UNITED STATES PATENT AND TRADEMARK OFFICE

APPLICATION NO.	FILING DATE	FIRST NAMED INVENTOR	ATTORNEY DOCKET NO.	CONFIRMATION NO.
10/080,849	02/22/2002	Aaron J. Hanna	K35A1056	9641

Office Action Summary

DETAILED ACTION

FIGURE 5

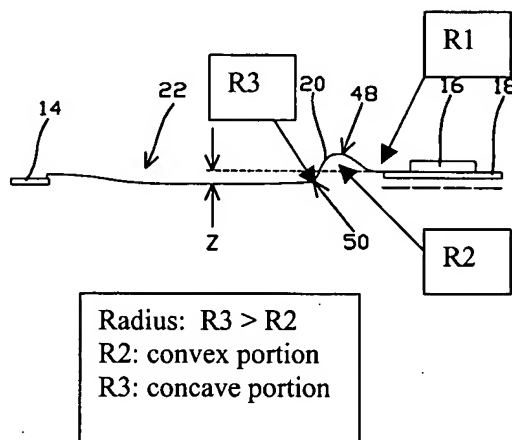
- Regarding claims 5, 10, 14, 18, 22, 26, 31, 36, 41, 46, 50 and 54, Jagt shows the radius geometry includes a first radius of curvature, a second radius of curvature and a third radius of curvature, the first radius being closer to the mount plate than the second radius, the second

radius being closer to the mount plate than the third radius, and wherein the third radius is greater than the second radius [see Examiner's embedded Fig. 5].

In response to applicant's argument that the references fail to show certain features of applicant's invention, the Examiner maintains that Jagt et al. discloses a load beam [12] having a first end and a second end, the first end defining an integral hinge portion, the hinge portion defining a radius geometry that includes at least two radii of curvatures configured to lower load beam toward the disk such that the hinge portion defines at least one concave portion and at least one convex portion [col. 8, lines 8-38; Examiner's embedded Fig. 5];
